# Access Compliance Report

## Public Rights-of-Way

### (Curb Ramps)

Intersection ID: 17718	Main Street: N_SHARON_AMITY_RD	Cross Street: TANGLE_DR	Location: N
ADA ID: E9CCCB6BEAAC	Ramp Type: PerpDiag	Initial Pass/Fail: Fail	Overall Compliance: No
Severity Score: 13.75			
Codes/Mitigation Info/Possible Solution		Field Measurements/Component Compliance

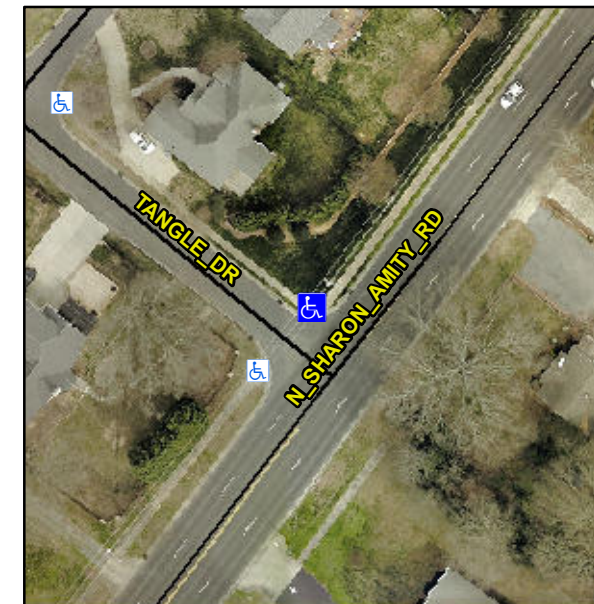
**R304.2.2, R304.5.3**

Compliance	Description	Data	Compliance	Description	Data
N/A	Ramp Length (in)	88.0	No	Ramp Slope (%)	8.7
Yes	Ramp Width (in)	49.0	No	Ramp XSlope (%)	3.7
N/A	Flare Type LT	N/A	N/A	Flare Type RT	N/A
N/A	Flare Slope LT (%)	N/A	N/A	Flare Slope RT (%)	N/A
N/A	Flare Traversable LT?	N/A	N/A	Flare Traversable RT?	N/A
N/A	Landing Length (in)	N/A	N/A	DWS Provided?	N/A
N/A	Landing Width (in)	N/A	N/A	DWS Contrast?	N/A
N/A	Landing Slope (%)	N/A	N/A	DWS Length (in)	N/A
N/A	Landing X Slope (%)	N/A	N/A	DWS Full Width?	N/A
N/A	Landing Curb? (Y/N)	N/A	N/A	DWS Offset (in)	N/A
N/A	Shared Landing?	N/A			
N/A	Gutter Ponding?	N/A	N/A	Gutter Slope (%)	N/A
N/A	Gutter Lip Ht (in)	N/A	N/A	Gutter X Slope (%)	N/A
N/A	Painted X Walk1?	No	N/A	Painted X Walk2?	No
	X Walk 1 Direction	To SW		X Walk 2 Direction	To SE
N/A	X Walk 1 Width (in)	N/A	N/A	X Walk 2 Width (in)	N/A
	X Walk 1 Slope (%)	5.4		X Walk 2 Slope (%)	3.7
	X Walk 1 X Slope (%)	3.6		X Walk 2 X Slope (%)	5.8

N/A	Ramp inside XWalk1?	N/A	N/A	Ramp inside XWalk2?	N/A
	Road Slope (%)	2.3	N/A	Clear Space?	N/A
	Road X Slope (%)	6.2	N/A	Clear Space to XWalk (in)	N/A
N/A	Any Obstructions?	N/A	N/A	Storm Grate/Utility Hazard?	N/A
	Obstruction Type			Storm Grate/Utility Type	
		N/A			N/A
		Yes		Surface Condition? (G/P)	Good

**Remove & Replace Curb Ramp With Two New Directional Ramps or Equivalent.**
